Swan Lake Small Boat Harbor Improvements Kotzebue, Alaska

Pre-Bid Conference

January 20, 2015

A TYPICAL TRANSVERSE SECTION
 S1.3 SCALE: 1/4" = 1'-0"

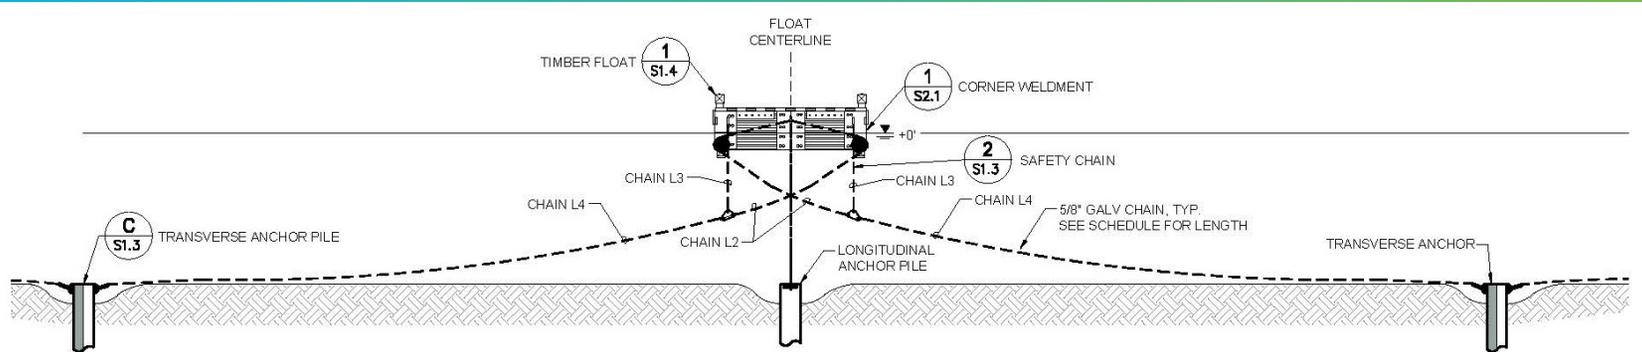
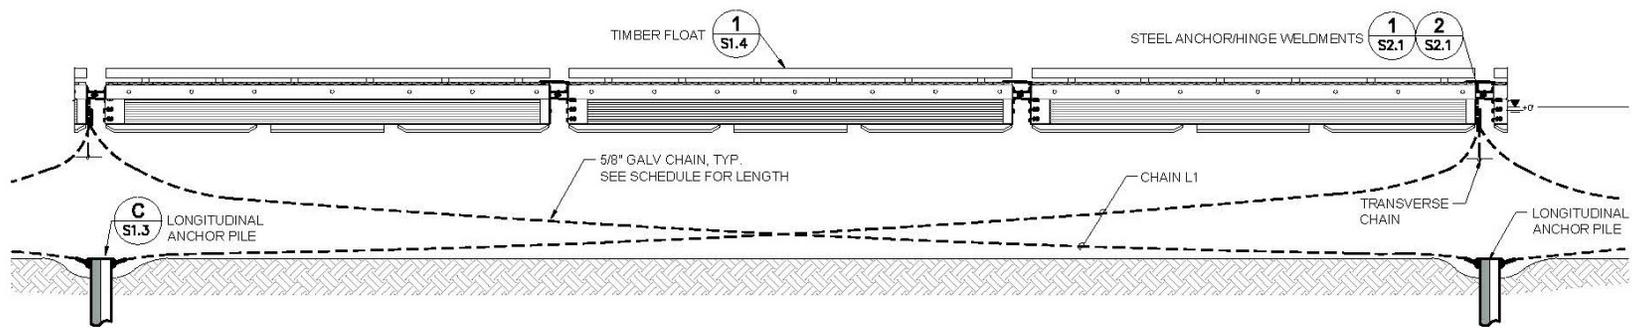
7. Drawing S1.3, Detail C shows the anchor pile in a hole in the seabed. Does the contractor have to clamshell a depression in the seabed prior to pile driving as is indicated. Please confirm. Additionally, if excavation is required can this material be sidecast adjacent to the pile location or does it have to be collected and dispose of upland....Please clarify.

Project Design – Electrical

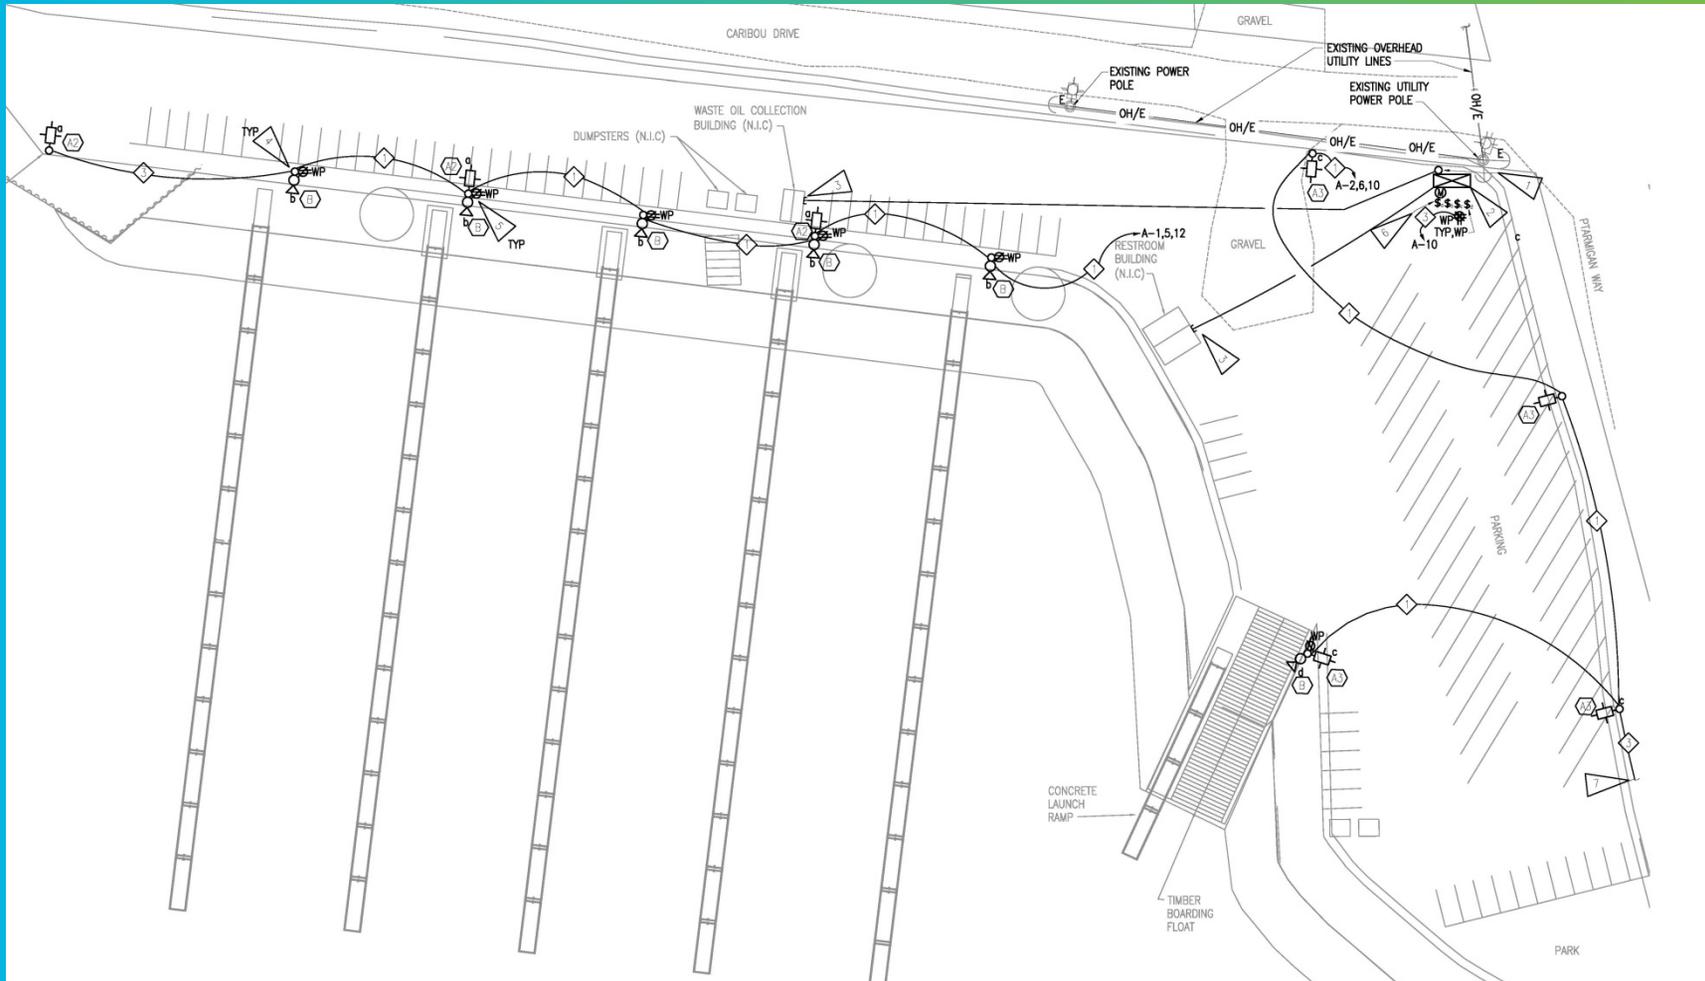
1. I was unable to find the specs on the City's website
2. Who will be the electrical inspector?
3. Request for clarification on a conflict between Specification 265600 2.3 B and Plan Sheet E2.1 Detail 2. This information is addressing the wind load rating of the composite light poles. The Spec calls out 130MPH + 1.3 Gust Factor. The plan sheet calls out 110MPH + 1.3 Gust Factor. Clarify the correct wind load rating
